651S-1
GENERAL PURPOSE HF RECEIVER

PUB NO.	NOTE	DATE	SUBJECT
IB 1-72 ✓		03/01/72	Subassembly Interchangeability
SB 1		10/01/72	Reduction of 450-kHz Leakage From Synthesizer Reference Board All
SB 2		06/06/73	Reduction of Noise Level
SB 3		07/15/73	Add Keep-Alive Frequency Memory Function
SB 4		07/15/73	Extend Comma and Decimal Lamp Life in Frequency Display
SB A ✓		11/01/73	Change DCFE Filter Switching Diode
SB 5	1	12/15/74	Minimize TCU Circuit Card Response to Data Link Noise and Failure
SB 6	2	03/01/75	Reduce Intermodulation Level
SB 7		02/07/75	Reduce Internal Spurious Signals
SB 8		12/27/74	Allow Remote Control Operation With RS-232C Serial Control Interface Card A9
SB 9 ✓		02/15/75	Increase Life of Display Tubes
SB 10 ✓	2	12/31/75 Revised 08/02/76, 04/01/77	Replacing Display Tubes With LED Plug-in Assemblies
SB 11		Not issued	
SB B ✓		11/15/74	KAV
SB C ✓		01/15/78	Supply KAV Power to DCFE
SB 12 ✓		05/01/78 Revised 07/01/78	Replacing Nonprocurable Integrated Circuits

SERVICE BULLETIN A

SUBJECT: Change DCFE Filter Switching Diode

P/O DCFE Circuit Card Assembly A8 (608-9322-001)
Figure 2

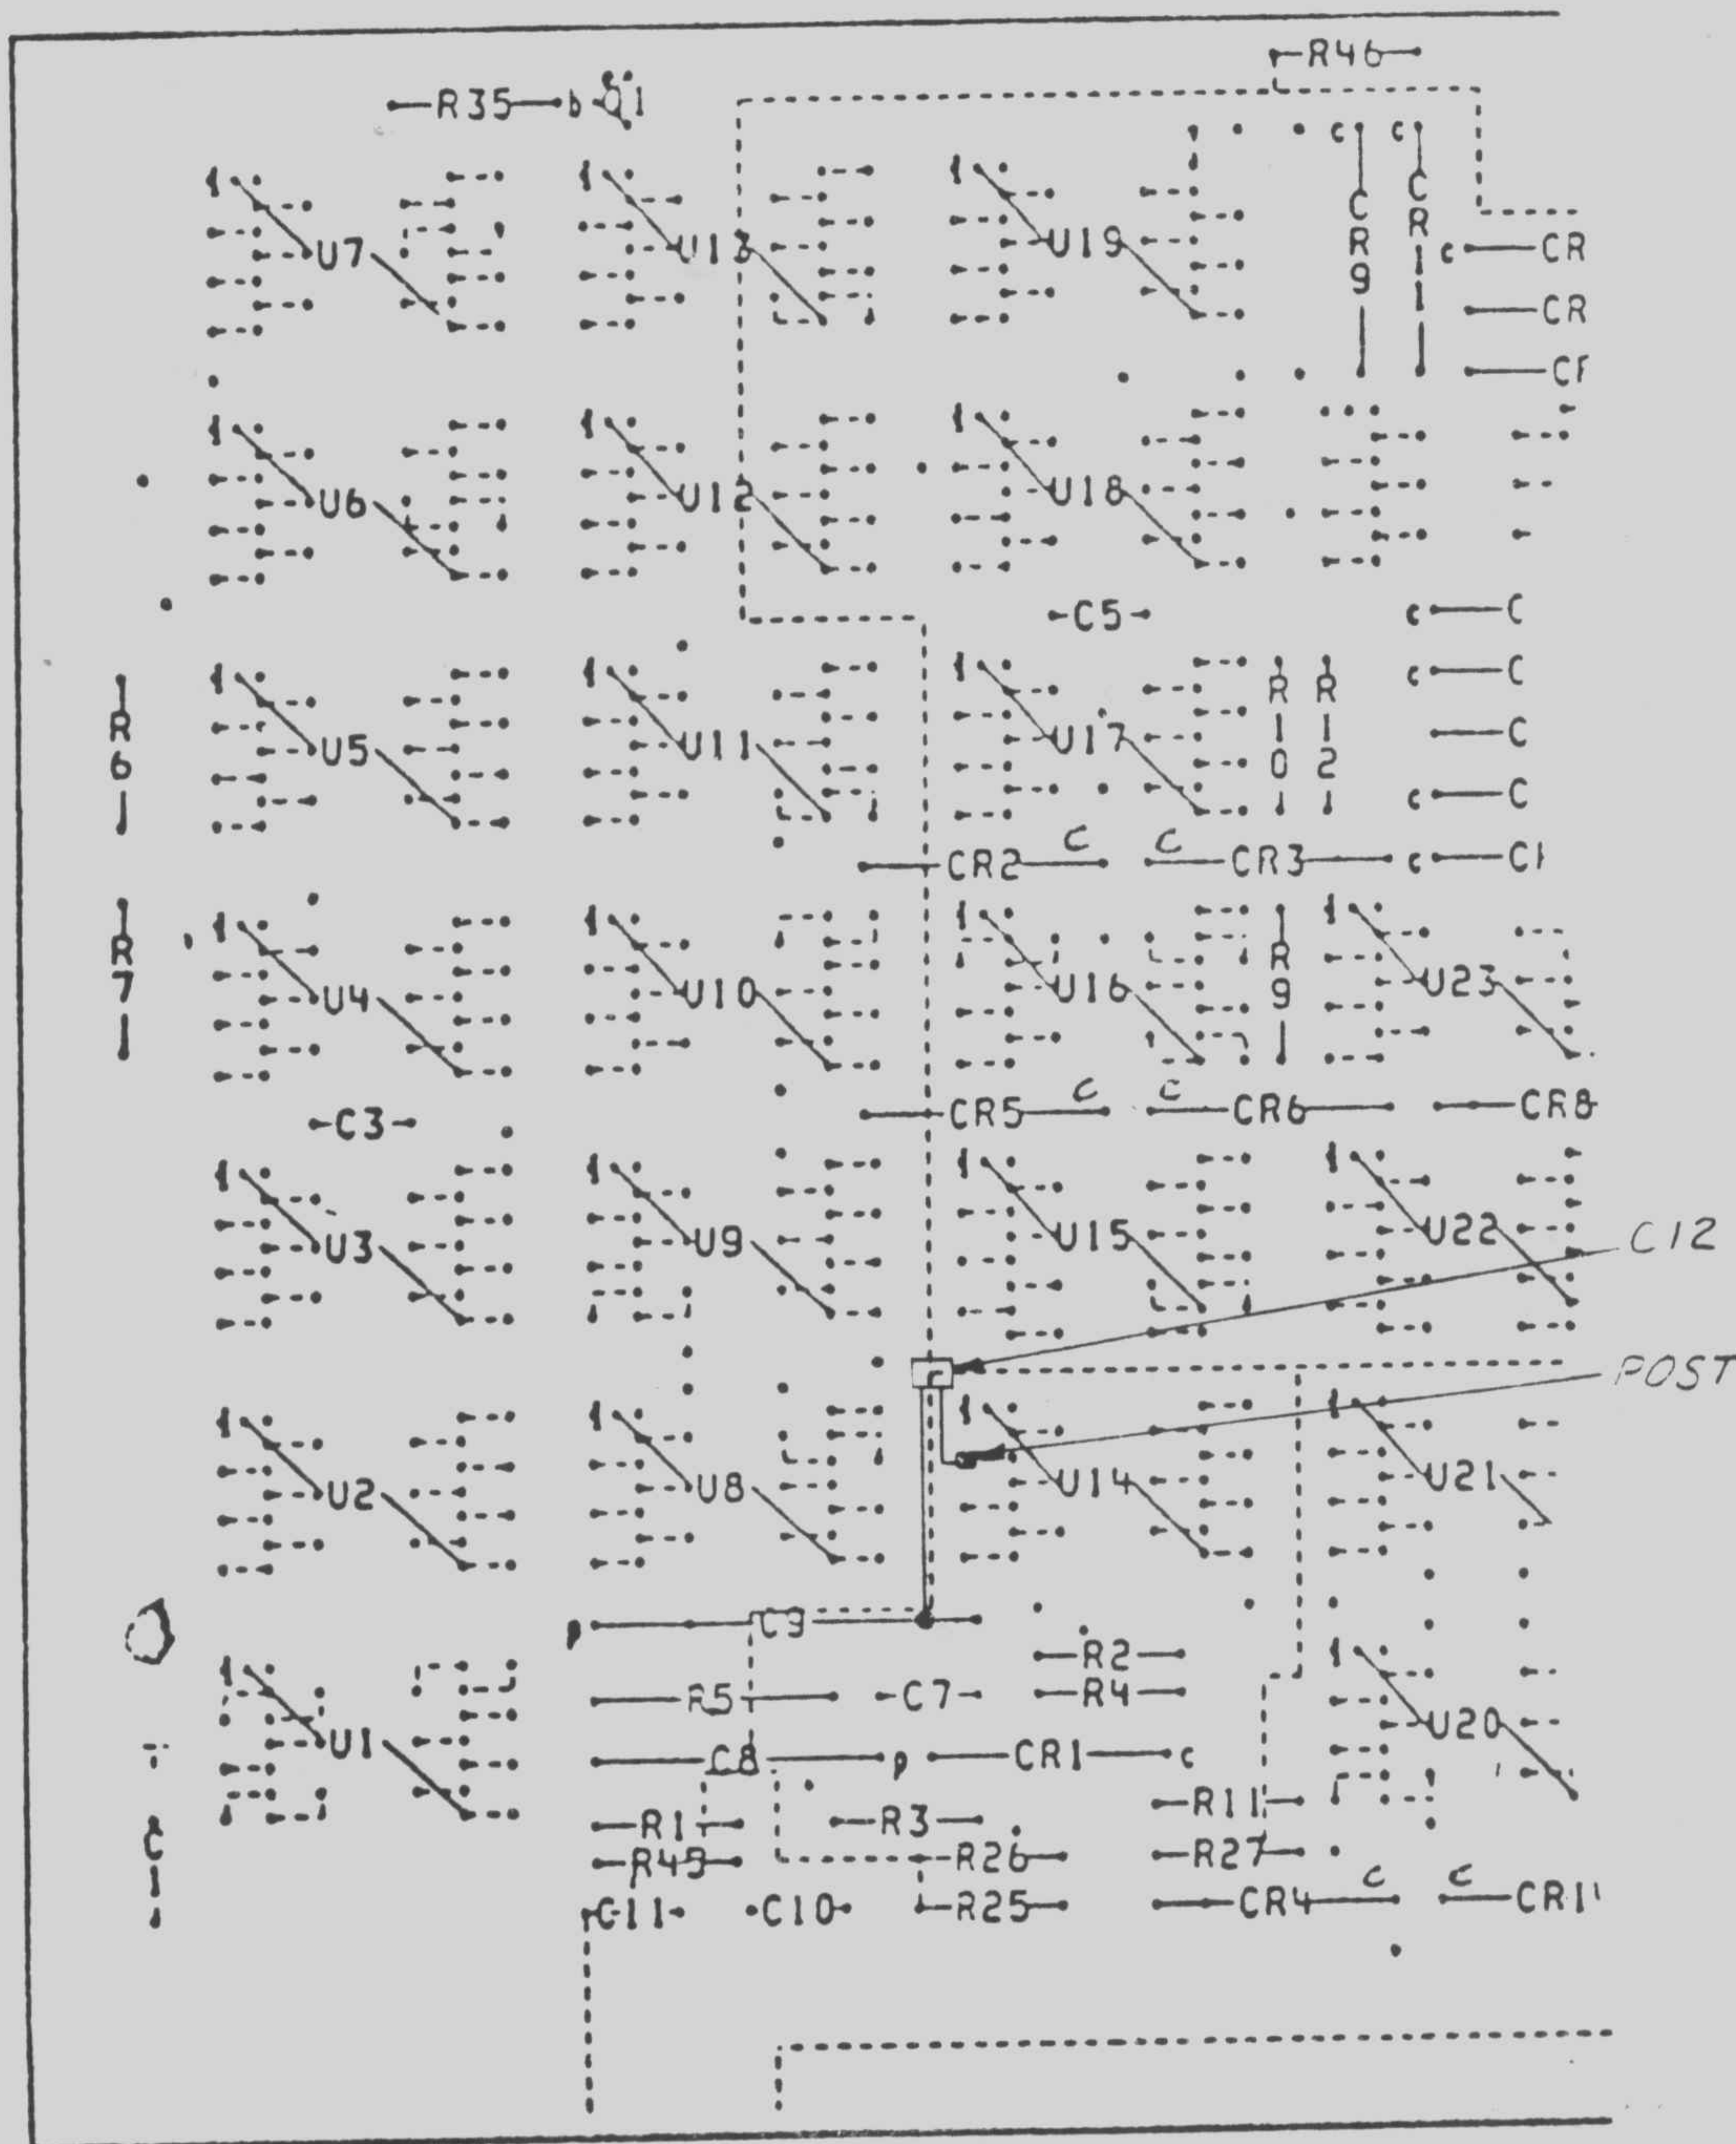
- G. Install a post (372-2601-010) at U14-3 on the top of the circuit card as shown in figure 2.

- H. Install a 1500-pF capacitor C12 (913-3279-040) between the new post and the ground lead of C9 as shown in figure 2. Use sleeving (152-2463-000) on the capacitor leads.

651S-1/1A Chassis, Bottom View
Figure 1

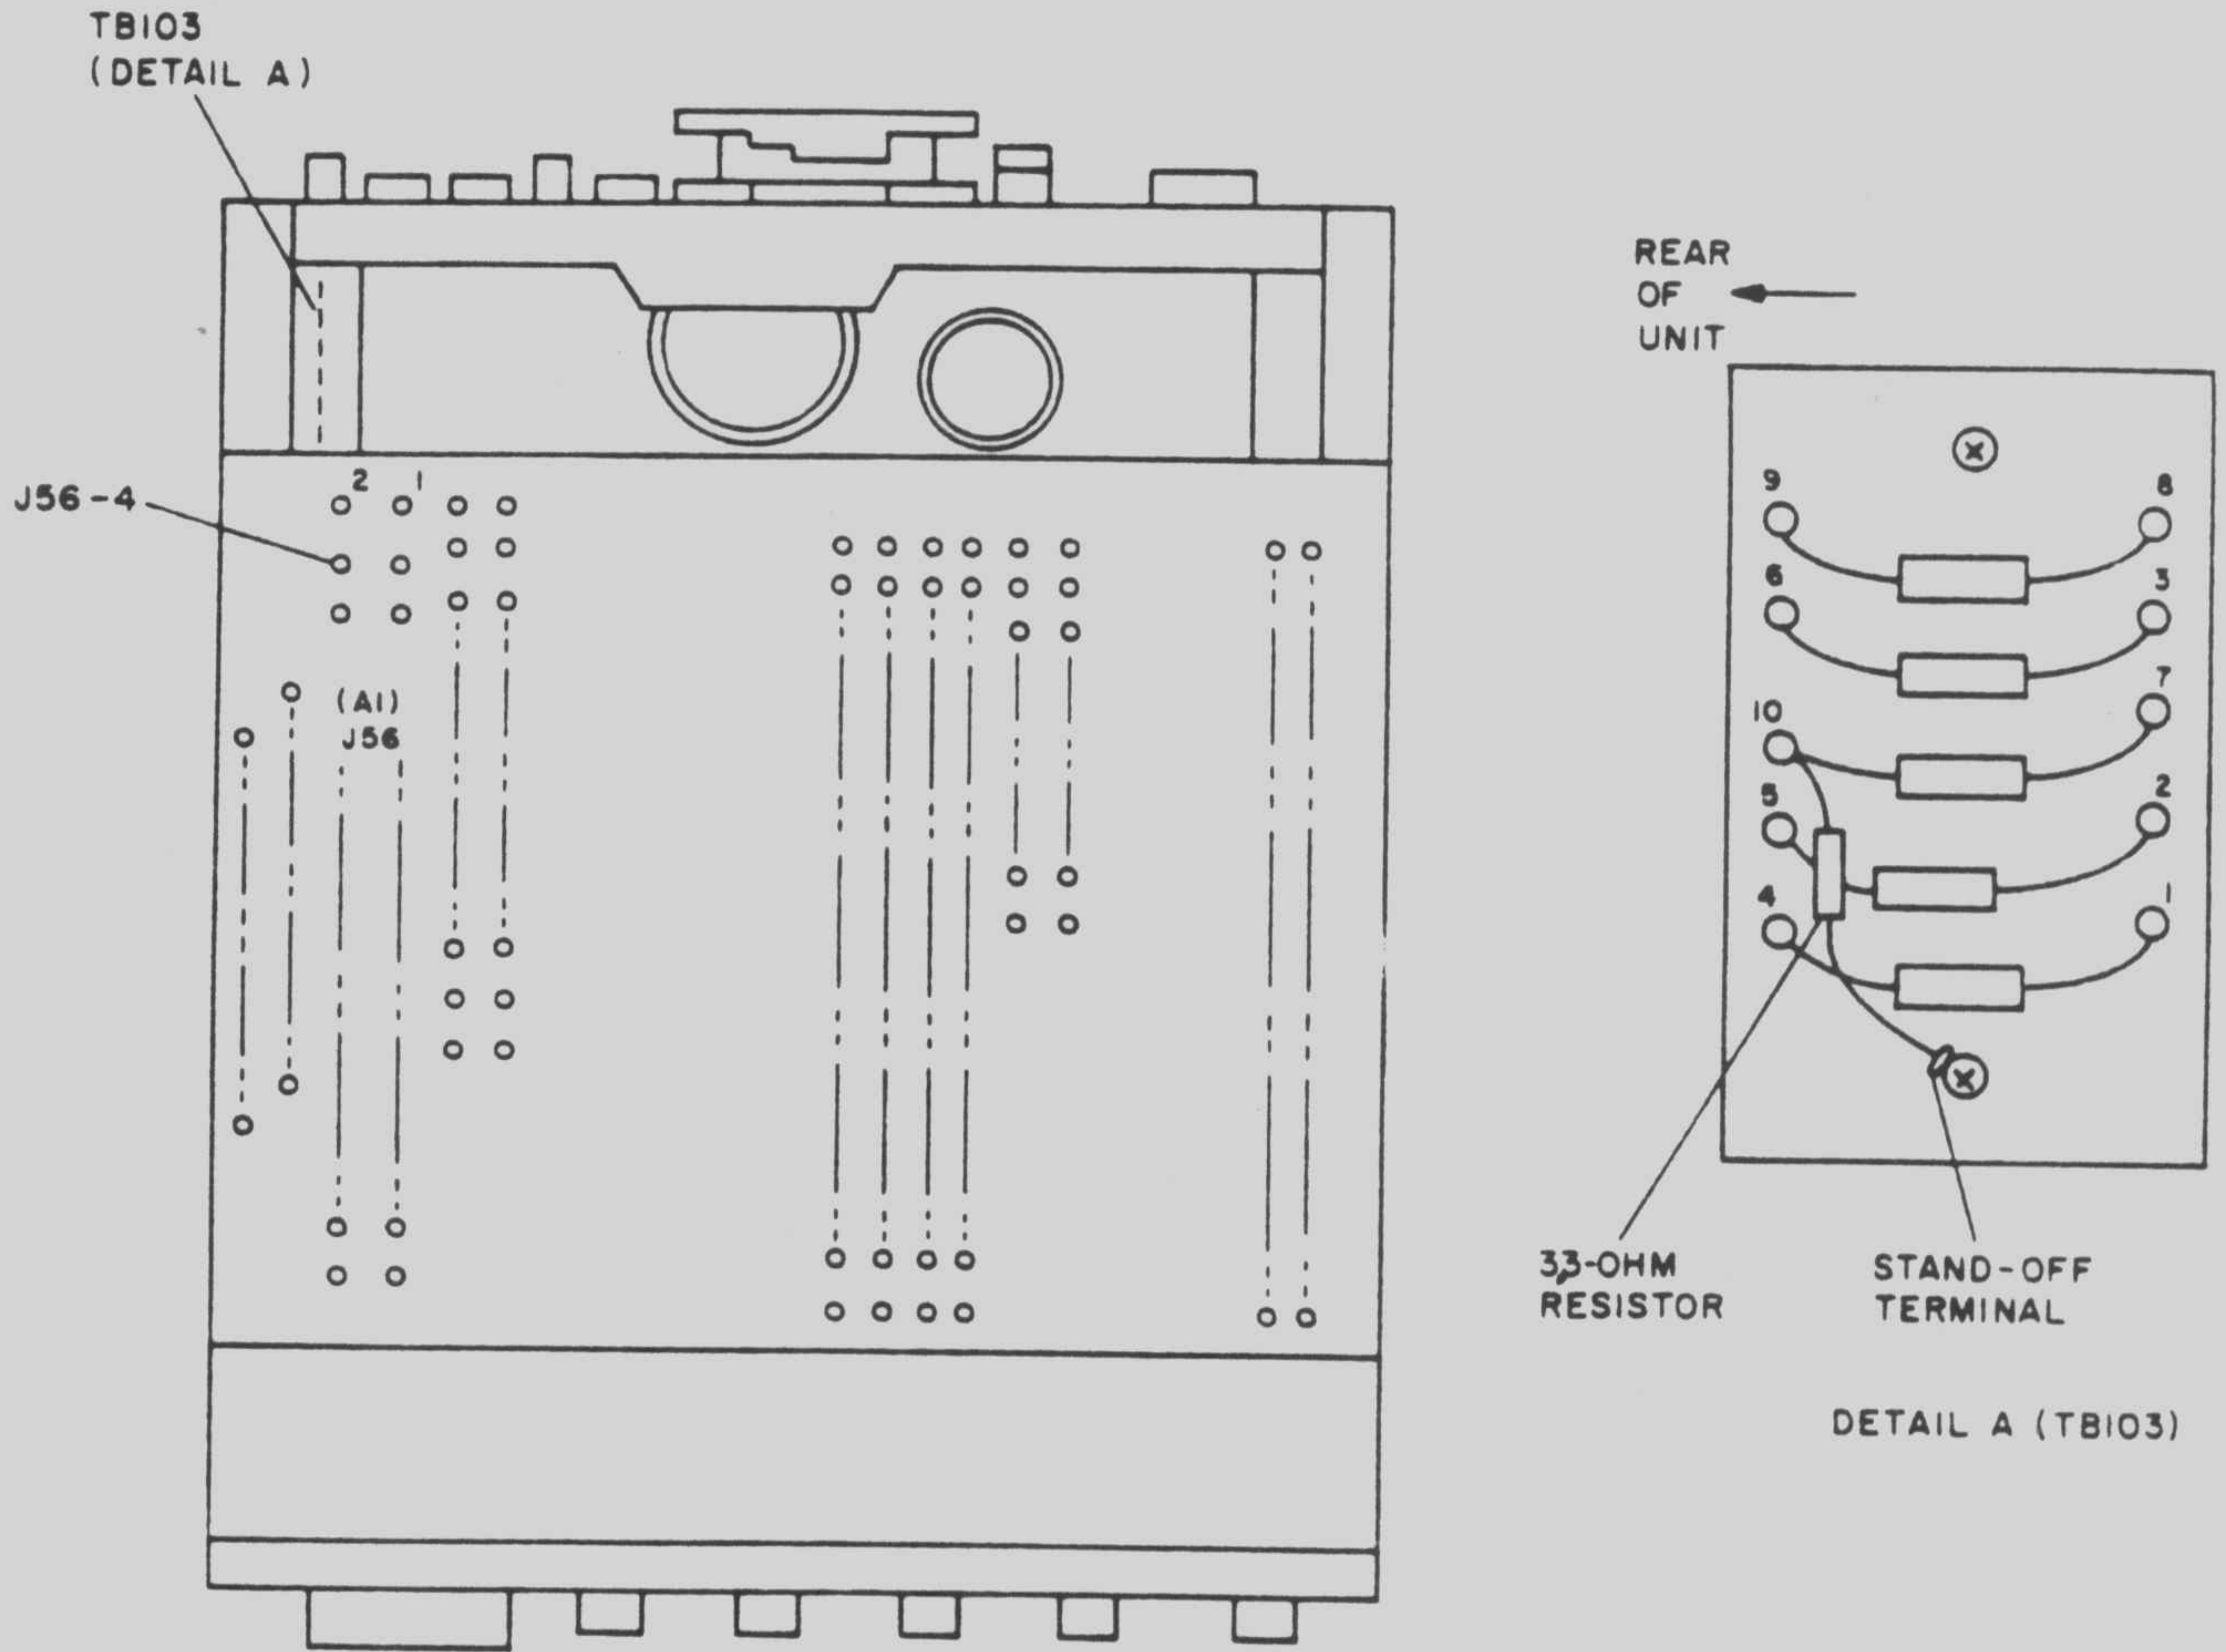
- A. Disconnect all external cables and wiring. Remove two screws from rear of unit and slide dust cover from the unit.
- B. Mount standoff terminal (306-1018-000) on TB103 (refer to figure 1).
- C. Mount 3.3-ohm resistor between the standoff terminal and TB103-10 and solder.

- D. Unsolder blue wire from J56-4. See figure 1. Pull this wire through the cable ties and connect and solder to the standoff terminal mounted in step B.
- E. Mark information chart (280-3778-010) with SB 9 and apply to chassis near nameplate.
- F. Slide cover back on unit and replace two screws on rear of unit.
- G. Reconnect external cables and wires and check that the display tubes light properly.
